ARMY ENGINEER DISTRICT NEW YORK  
NATIONAL DAM SAFETY PROGRAM. SALISBURY MILLS DAM, INVENTORY NUM--ETC(U)  
APR 78 C H BENN

MOODNA CREEK BASIN - SALISBURY MILLS DAM

PHASE I REPORT  
NATIONAL DAM SAFETY PROGRAM

SALISBURY MILLS DAM  
NEW YORK STATE  
ORANGE COUNTY  
MOODNA CREEK  
INSPECTED 5 JANUARY 1978

Sheet 1 of 4  
APP. A

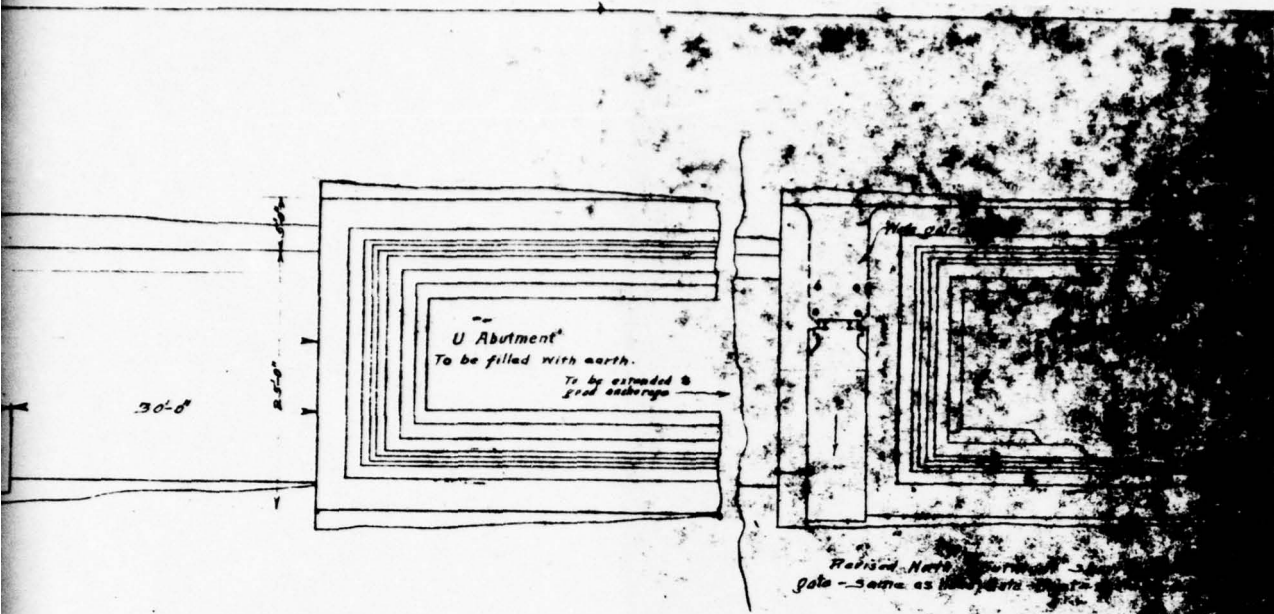
Third: Your letter dated May 17, 1921, indicates that the subfoundation material is "Utica Slate". However, the cross section at the dam site (on sheet 2 of your blue prints) does not extend the full width of the valley and up to the elevation of the top of the dam at the south end; A portion of the proposed spillway dam, as shown by the blue prints, would be located upon a rock surface (sloping down stream), into which it is shown to be imbedded to a depth of about 2 feet at the downstream toe. The question naturally arises whether or not such a depth of embedment would insure safety against sliding under all conditions, and whether a suitable quality of rock for a subfoundation would be available at that depth; why is cutoff wall under the spillway section not shown beneath the upstream heel, rather than at a distance several feet downstream from same; sheet 3 of the blue prints shows that the proposed concrete intake chamber is to be constructed upon the surface of rock sloping rather steep in a downstream direction. The concrete forming this portion of the dam should be embedded to a satisfactory depth to insure proper subfoundation conditions and prevent any possibility of a failure by sliding.

Third The cross section at the dam site (on sheet 2 of blue prints) does not extend the full width of the valley and up to the elevation at the top of the dam on the south end, as that is shown on details for the proposed intake which is adjacent to the south bank upon which is situated the mill buildings. With the dip of the rock as described in my letter of May 17th, there is no reason to expect other than a suitable quantity of rock for a sub-foundation upon excavation for the dam, and as such structure is a gravity type with the rough rock surface, and embedded about 2 feet into the rock, there would be no question as to safety against sliding, the dip of the rock being up-stream and at a considerable angle would insure a favorable sub-surface, although, if you so desire anchor bolts could be inserted for the base.

We believe the spill should be able to accommodate a flood of at least 16,000 c.f.s. Will you send a corrected print of sheet 2 of 4 showing the spillway area and overturning forces on the section, marking off the forces.

The elevation of 322.40 shown on the stress sheet in extreme  
high water was taken from information obtained on the ground, at the  
site of the present dam and the proposed new dam, as the maximum high  
water mark which had been reached in the existence of the mill in  
this location. However the design of this dam will be safe in either  
case.
